**Written Representation
for the
Royal Society for the Protection of Birds
Annex A
Offshore Ornithology**

**Comments on selected Deadline 5 and Deadline 5a submissions
Submitted for Deadline 6
27 July 2022**

**Application by Hornsea Project Four Limited for an Order
Granting Development Consent for the Hornsea Project Four Offshore Wind
Farm**

Planning Inspectorate Ref: EN010098

Figure 1. The predicted annual mortality of guillemot apportioned to the Flamborough and Filey Coast SPA arising from Hornsea Project Four alone and in-combination presented as ranges using the Applicant’s approach, the plausible range and the probable range of displacement and mortality rates

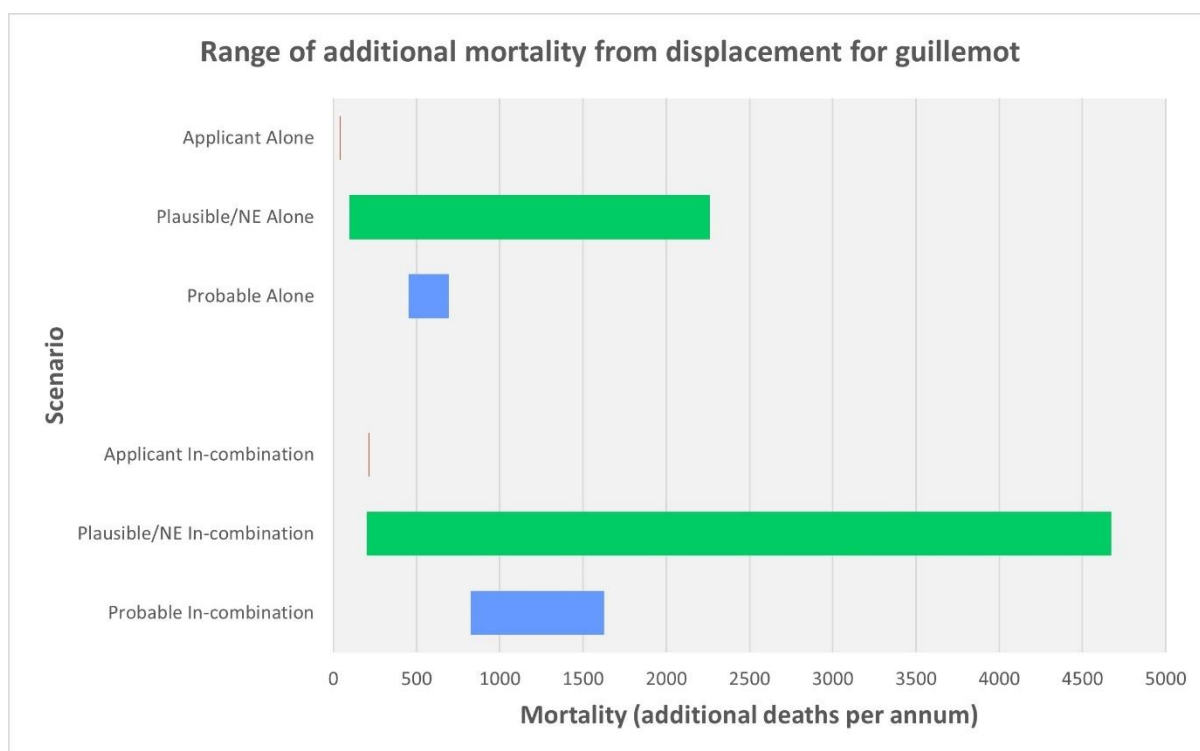
- 8.5. These figures show, that for **guillemot**, the additional mortality predicted to arise through displacement will result in the Flamborough and Filey Coast SPA population being a probable **13.9-20.6%** lower after the lifetime of Hornsea Project Four wind farm than it would be without the development, and **24.0-41.7%** lower in-combination with other developments, although plausibly it could be as much as 53.1% lower through the project alone, and 79.4% in combination.

Figure 3. The predicted annual mortality of razorbill apportioned to the Flamborough and Filey Coast SPA arising from Hornsea Project Four alone and in-combination presented as

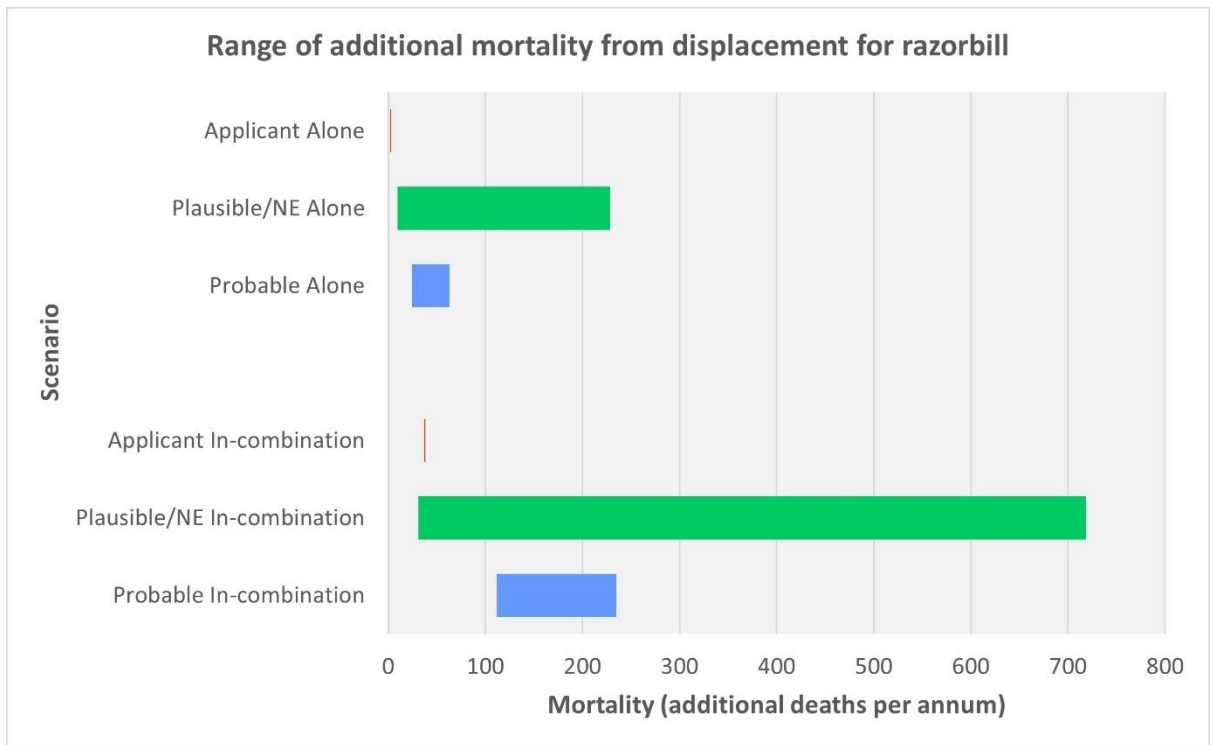
- 8.6. For **razorbill**, the additional mortality predicted to arise through displacement will result in the Flamborough and Filey Coast SPA population being a probable **2.5-6.4%** lower after the lifetime of Hornsea Project Four wind farm than it would be without the development, and **11.1-21.9%** lower in-combination with other developments, although plausibly it could be as much as 21.4% lower through the project alone, and 53.4% in combination.
